**Origination Form**  
 Proposed Revisions to a Standard Plans Index

<b>Originator:</b>	Gibbs, Shae	<b>Index Number:</b>	646-001
<b>Date:</b>	9/4/2025	<b>Sheet Number(s):</b>	1
<b>E-mail:</b>	shae.gibbs@dot.state.fl.us	<b>Index Title:</b>	Aluminum Post and Pedestal Mounted Pedestrian Detectors and Signals

ALUMINUM POST AND PEDESTAL MOUNTED  
PEDESTRIAN DETECTORS AND SIGNALS

INDEX  
646-001

SHEET  
1 of 1

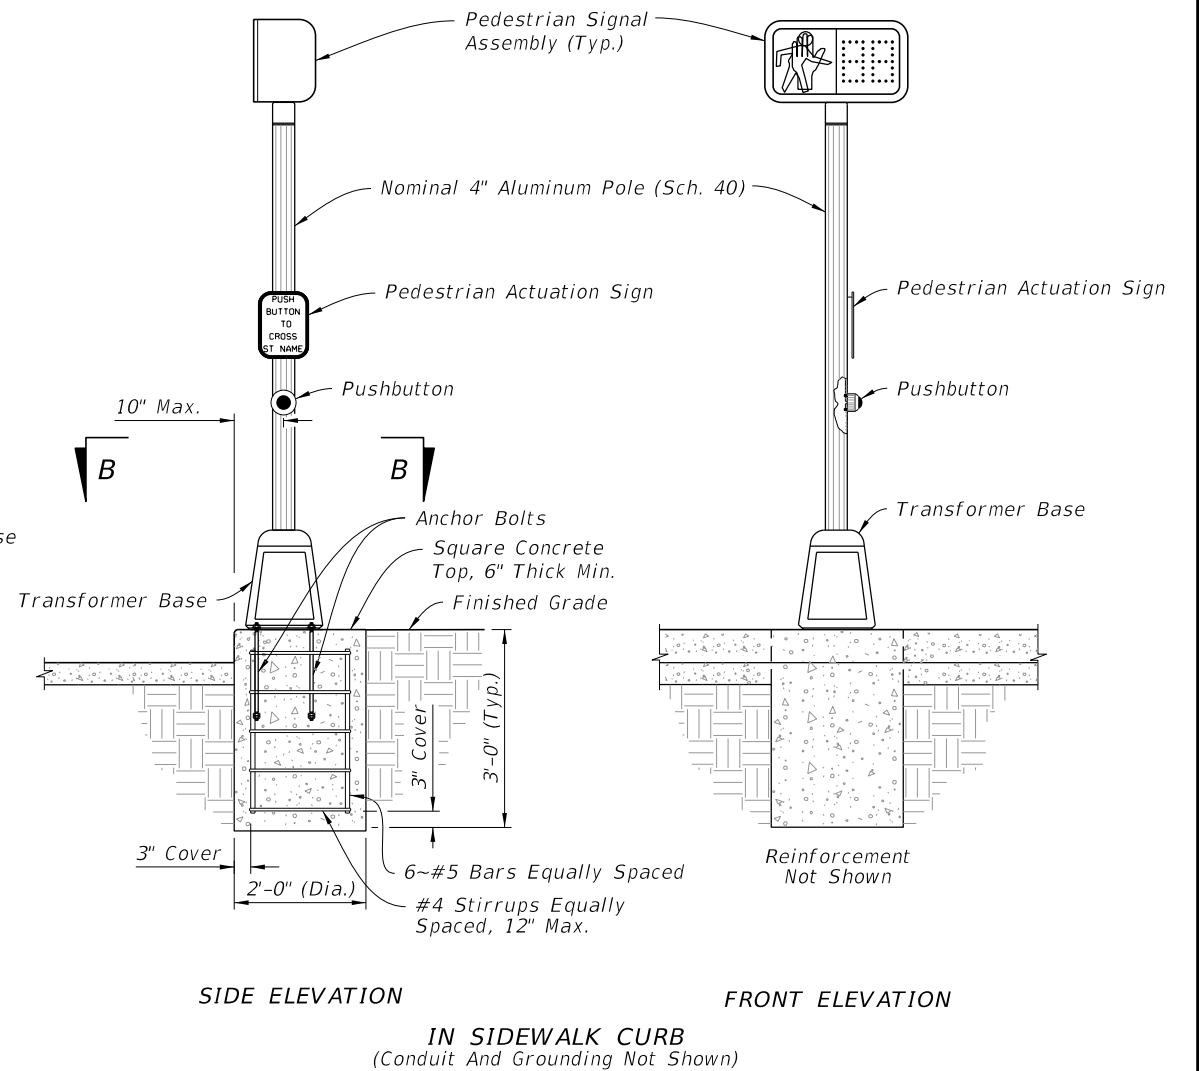
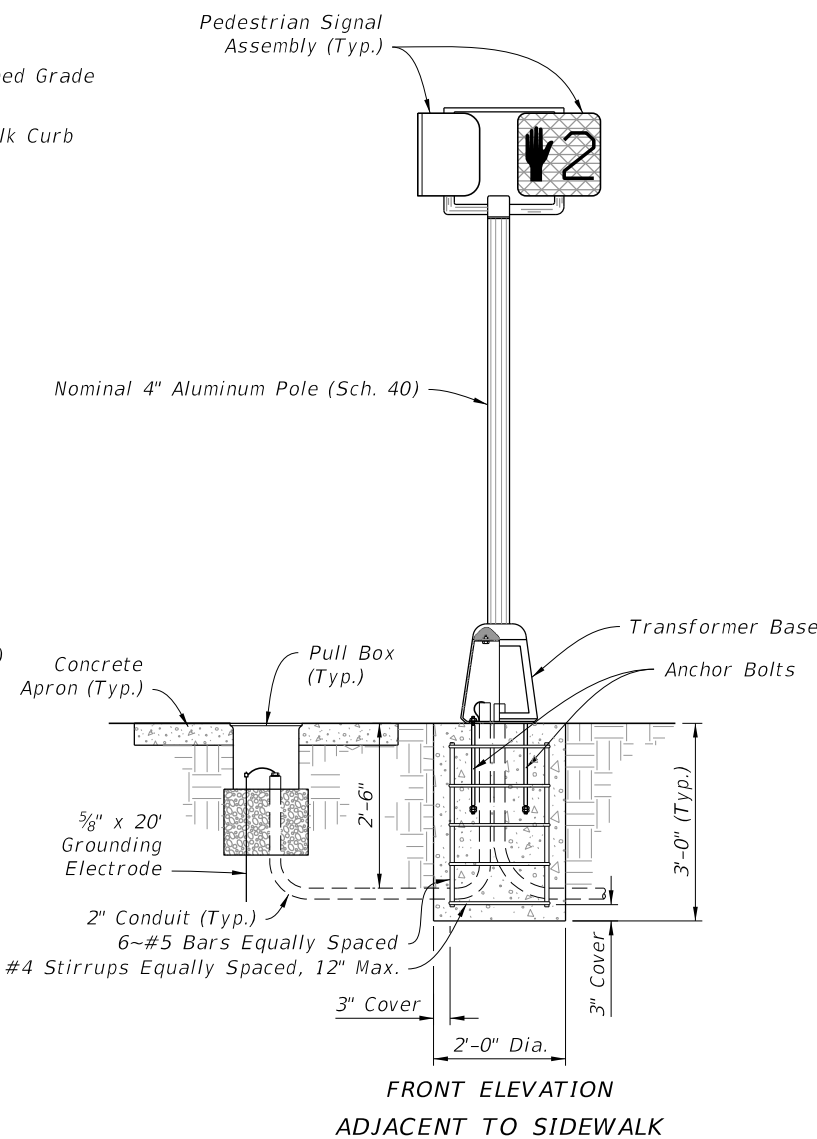
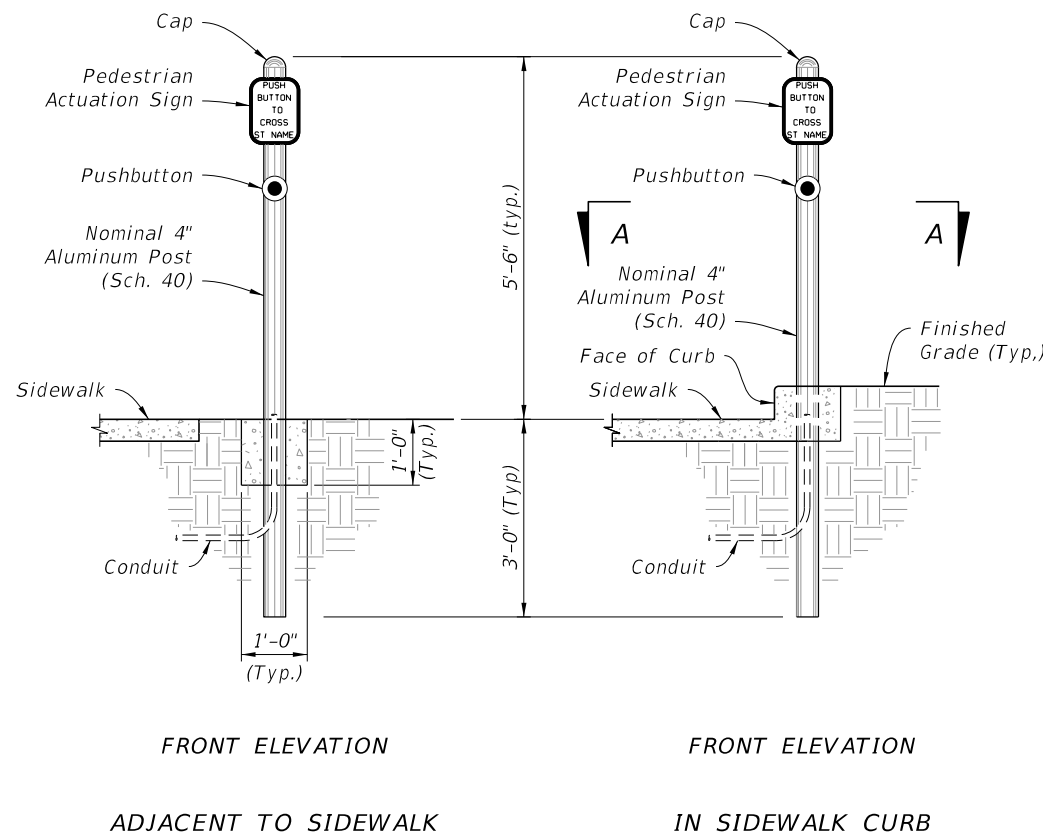
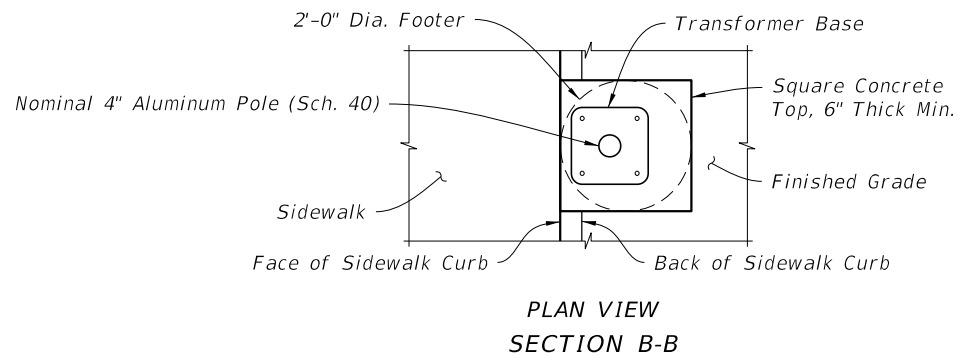
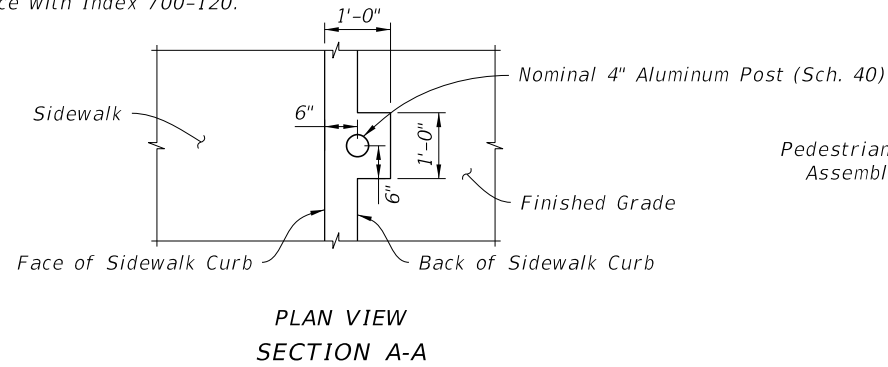
Sheet 1: Added Note 7 "For pedestal mounted signals, route and terminate the grounding electrode conductor to a ground lug within the transformer base."

This note was added to correspond with Standard Plans Index 653-001 in coordination with the TERL.

**7. For pedestal mounted signals, route and terminate the grounding electrode conductor to a ground lug within the transformer base.**
